Economic Commission for Europe**Inland Transport Committee****World Forum for Harmonization of Vehicle Regulations****Working Party on General Safety Provisions****107th session**

Regulation No. 43 (Safety glazing)**Proposal for Supplement 3 to the 01 series of amendments to Regulation No. 43 (Safety glazing)****Submitted by the expert from Germany ***

Figure 6
Sand drop equipment

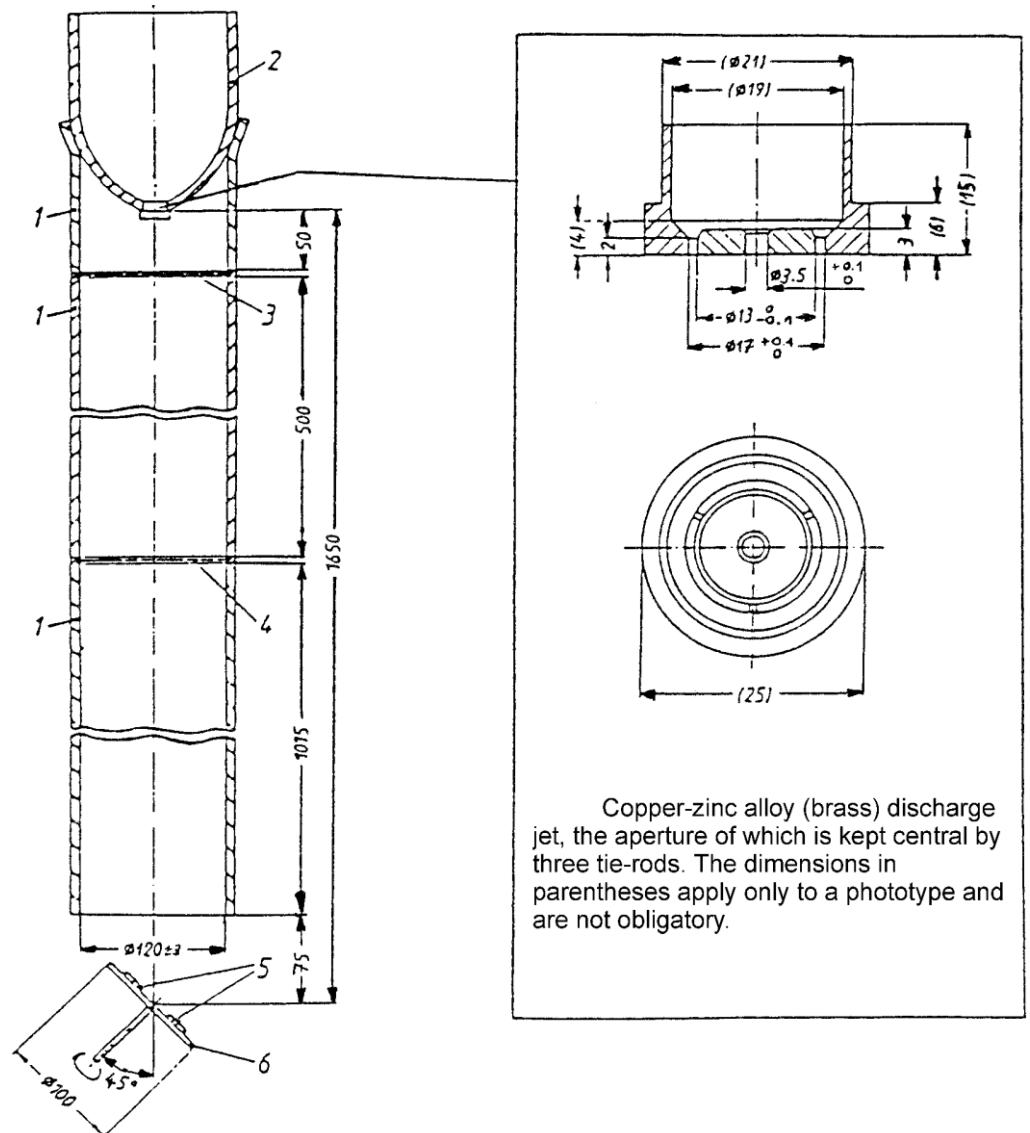
Annex 3, insert a new paragraph 4.7. (including a new Figure 6), to read:

The sand drop test equipment shall consist essentially of that illustrated in Figure 6. The gravity tube consists of three separate rigid polyvinylchloride tubes (PVC hard) of the same diameter, with two polyamide sieves mounted in between. The sieves should have a mesh size of 1.6 mm. The speed of the turntable shall be 250 ± 10 rev/min.

Figure 7

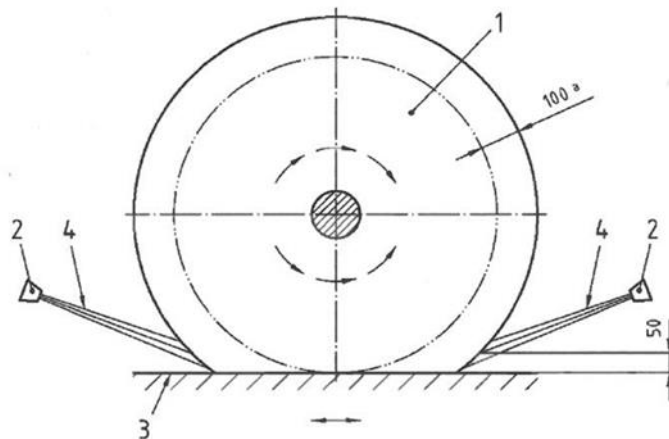
Annex 3, insert a new paragraph 4.8. (including new Figures 7 to 10), to read:

penetration depth (100 ± 20) mm (see Figure 7)

Figure 8
Calibration arrangement

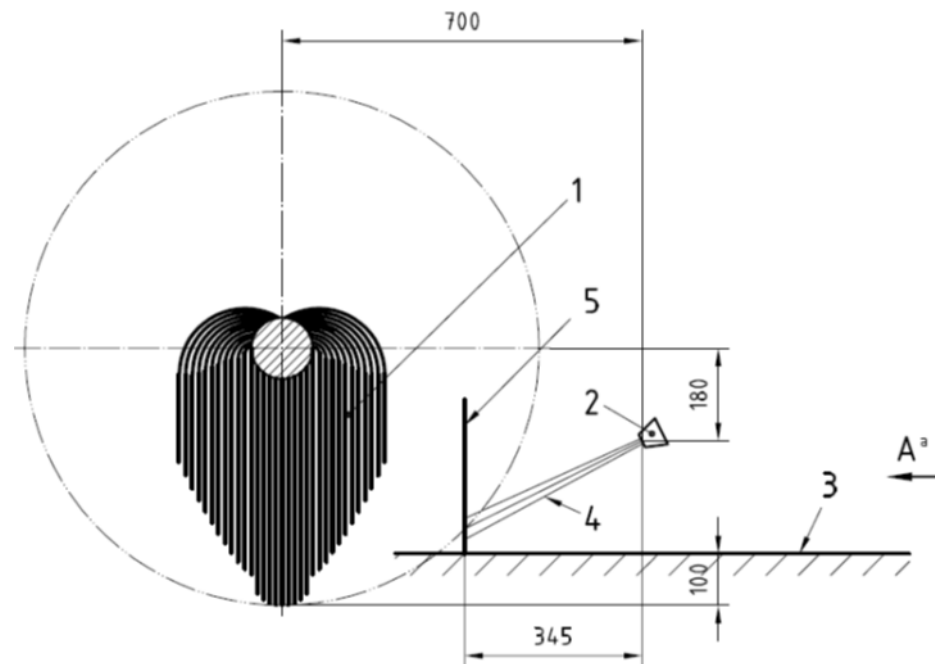
The two nozzles shall spray alternately and against the direction of travel of the test panel holder. They shall produce the specified spray pattern (see instrument calibration in Figure 8).

4.8.4.1.3. Do the instrument calibration as follows: Set up the equipment as shown in Figure 8. Fill with washing suspension (see paragraph 4.8.2. of this annex and wet the brush sufficiently. Determine the flow rate of the water, $(2.2 \pm 0.1) \text{ l/min.}$, by measurement and adjust by altering the pressure, $(300 \pm 50) \text{ kPa}$. Check the spray pattern of the nozzles (see Figure 9) If the spray pattern cannot be achieved or if the pressure regulation exceeds the tolerances, check, and if necessary replace, the nozzles.

Figure 10
Description of sample positioning on the test panel holder

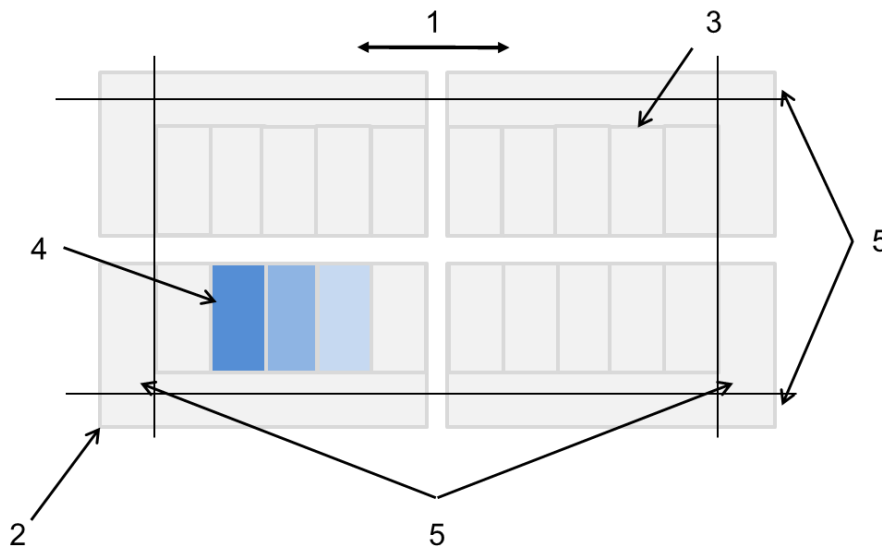
- 4.8.4.2.1. Affix the samples with the outside surface face up onto a supporting plate by using a double-faced adhesive tape (Sample positioning on the test holder as shown in Figure 10).

Figure 11

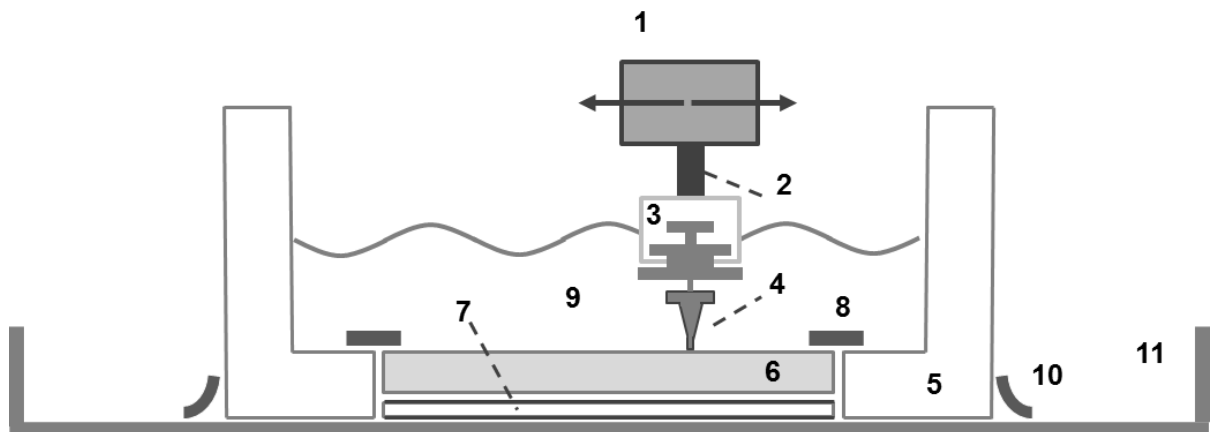
Annex 3, insert a new paragraph 4.9. (including new Figures 11 to 16), to read:

- 4.9.1.2. A wiper carriage assembly (see 1 in the Figures 11 and 12) having a beam which spans across the width of the base apparatus and can be mounted at its ends to the pillars, furthermore this carriage assembly has two self-supporting arms (see 2 in the Figures 11 and 12) where a wiper holder can be attached (the distance between the sample surface and bearing of self-supporting arm at the carriage assembly is 100 to 105 mm),**

- 4.9.1.3. A wiper holder² (see 3 in the Figure 11) suitable to attach a normal wiper blade (see 4 in the Figure 11) and adjusted to provide a load of 15 ± 0.5 g/cm (the weight of the wiper blade and its holder together with the wiper blade width determine the wiper load in g/cm),**

- 4.9.1.4. Two sample boxes³ (see 5 in Figure 11 and 12) made out of inert, material in the interior dimension of 200 mm x 120 mm (50 mm height) used to be filled with the aqueous suspension and having a hole at the bottom⁴ where the test sample can be inserted and therefore used as a test sample holder,**

Figure 13
Cross profile of the chloroprene type rubber blade

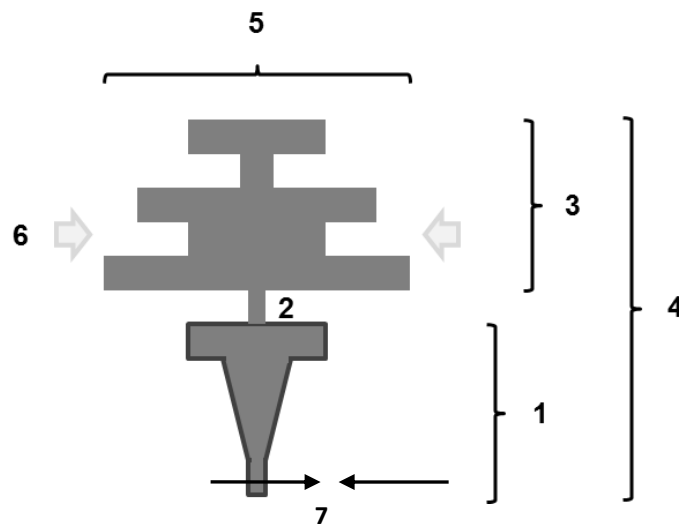
⁶ a suitable wiper blade can be e.g. Bosch "H-Stoff P6.3" with a cross profile as shown in Figure 13, or its successor "H-Stoff P32" or equivalent. A complete description of the blade, including its hardness value, its mechanical properties and the composition and thickness of its coating shall be added to the test report.

Figure 14
Equipment pre-check

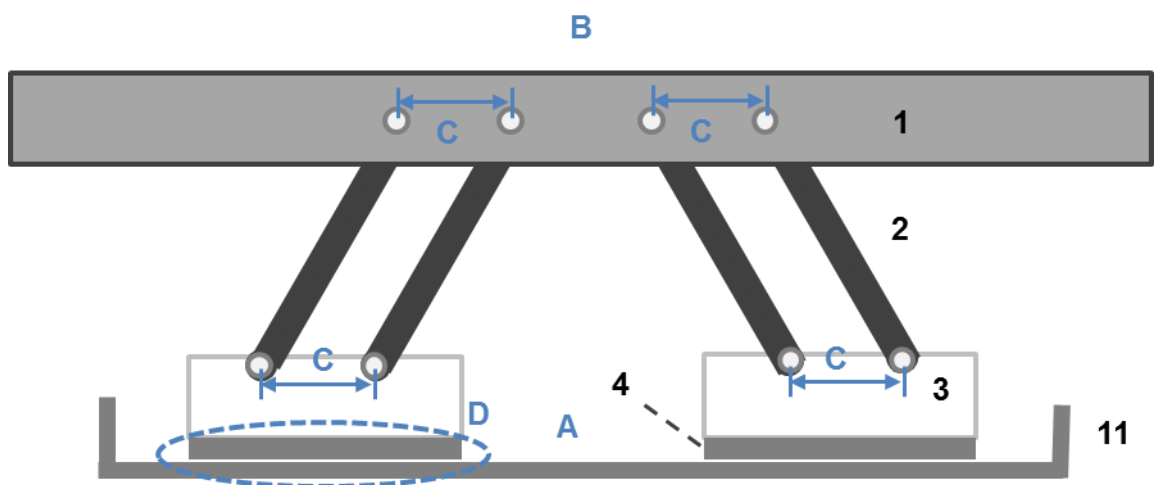
4.9.5.2. Test equipment pre-check**4.9.5.2.1. Before the equipment is used for testing samples the back and forth linear motion of the pillars of the base apparatus shall be checked for being uniform without any disturbance like getting stuck or starting to vibrate.****4.9.5.2.2. Build up the whole instrument including tray, wiper carriage assembly, wiper blade holders and new wiper blades but without sample box and sample (see Figure 14). To do so the two new wiper blades shall be mounted to their respective wiper blade holders and the latter ones shall be fixed to the carriage assembly. Then align using a spirit level the base plate where later the sample box will be placed and the wiper carriage assembly. Check that the distances of the two bearings of both self-supporting arms at the wiper carriage assembly and at the wiper blade holder are identical. Furthermore control visually that the wiper blade rest on the base plate uniformly without losing contact to the base plate at any point of the wiper blade.**

Figure 15

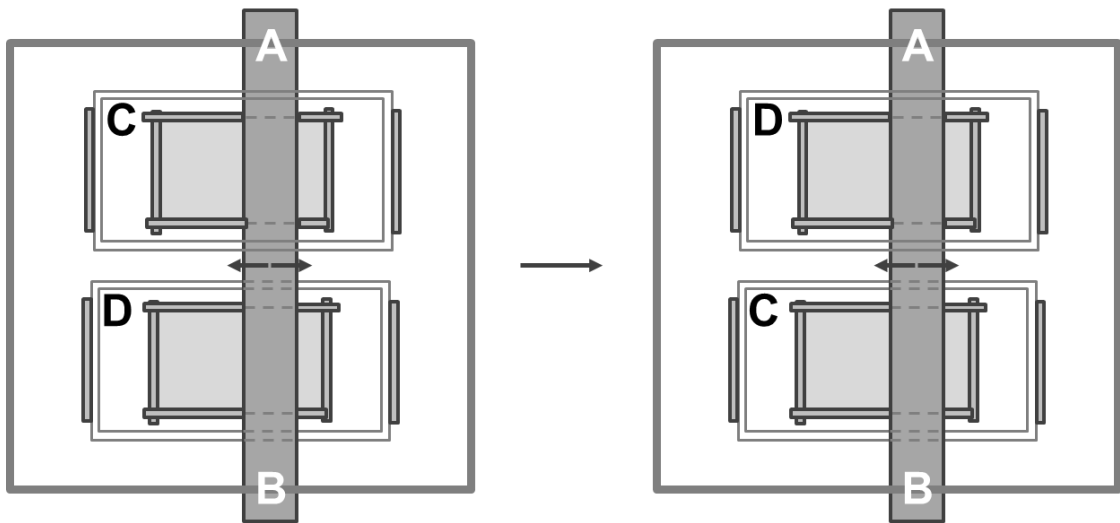
- 4.9.5.3.6. In order to ensure a homogenous abrading it is necessary to follow the action described below:
- 4.9.5.3.6.1. After half of the test cycle numbers [10.000 cycles] the test shall be stopped and the two sample boxes shall be exchanged without turning them (see Figure 15)¹⁰; this leads to an exchange for the two simultaneously tested samples regarding their wiper blades and furthermore alters the alignment of the self-supporting arm carrying the blade (from left to right or the other way round).

Figure 16

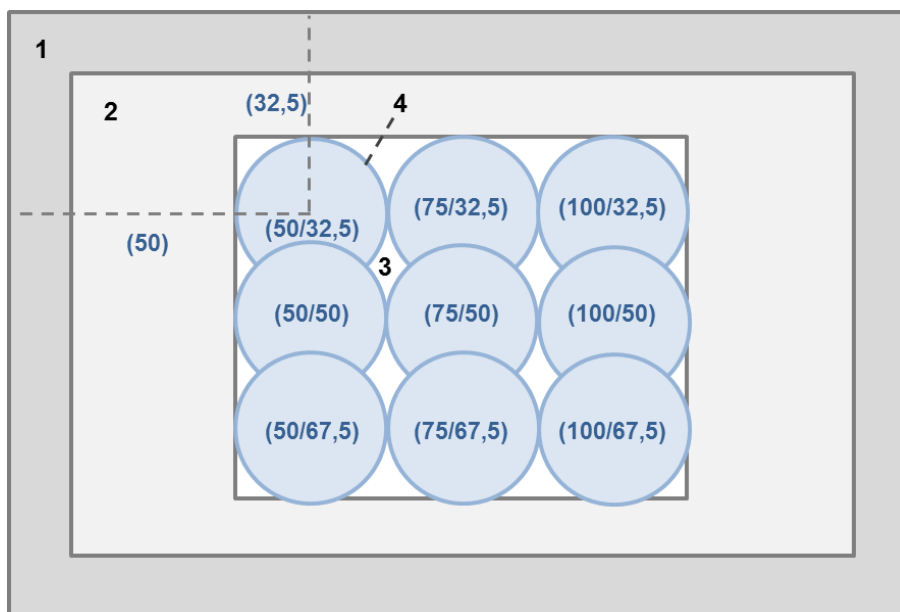
The initial haze value according to Annex 3, paragraph 4.4.3. of this Regulation of the test sample is measured at 9 measurement points across the sample (see 4 in Figure 16).

4.9.5.4.4. Nine measurement points according to the Figure 16 below shall be used to determine the delta haze at these points and calculate an average delta haze afterwards.

Design Drawing of the Wiper Blade Holder

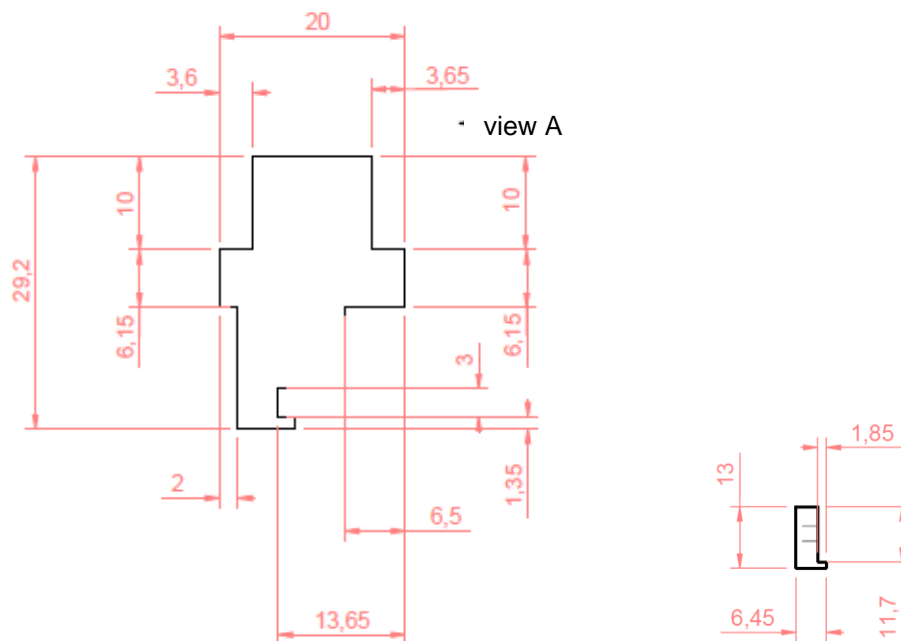
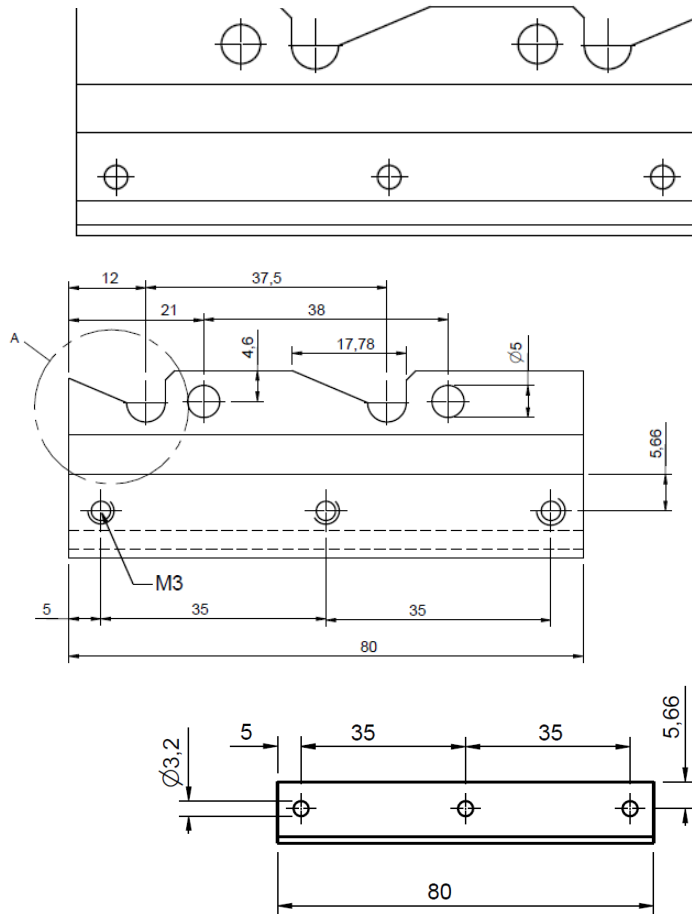
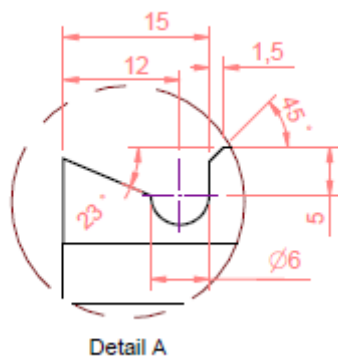
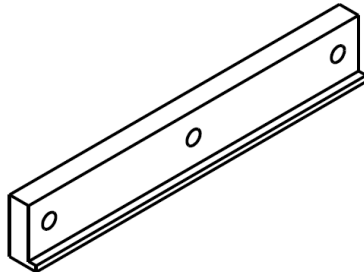
² For a design drawing see Appendix 1.

Annex 3, insert new Appendix 1, to read:

Design Drawing from the Sample Box

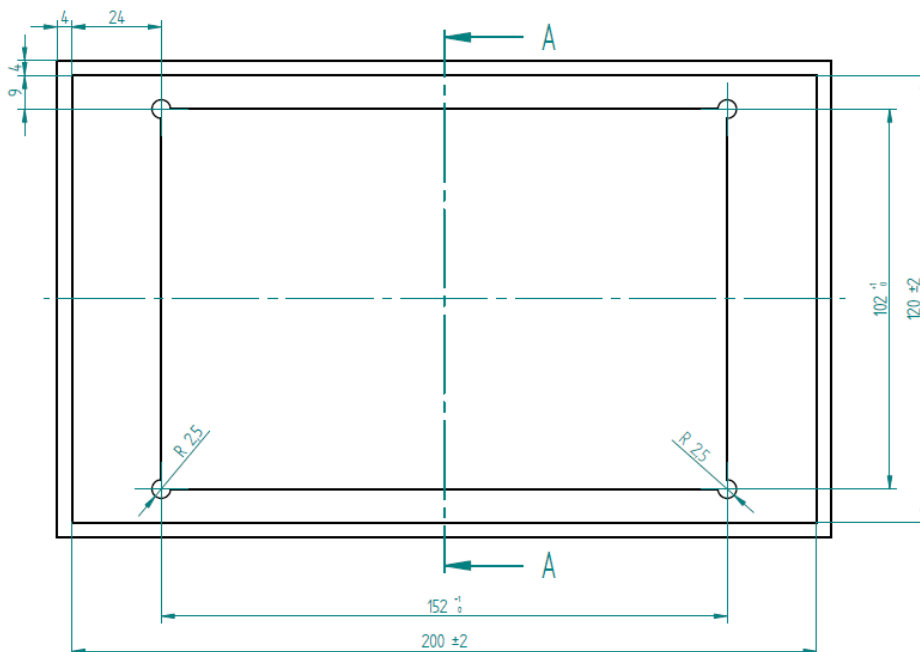
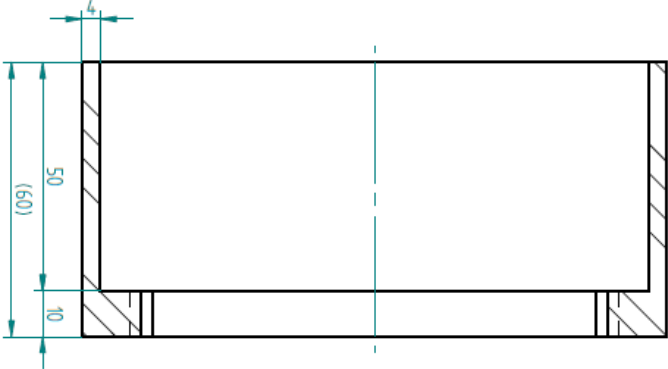
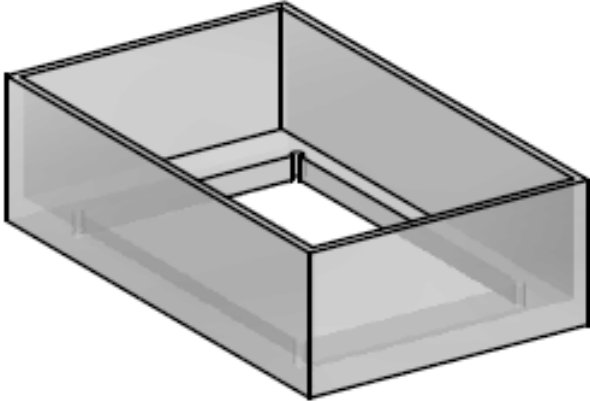
³ For a design drawing see Appendix 2.

Annex 3, insert new Appendix 2, to read:
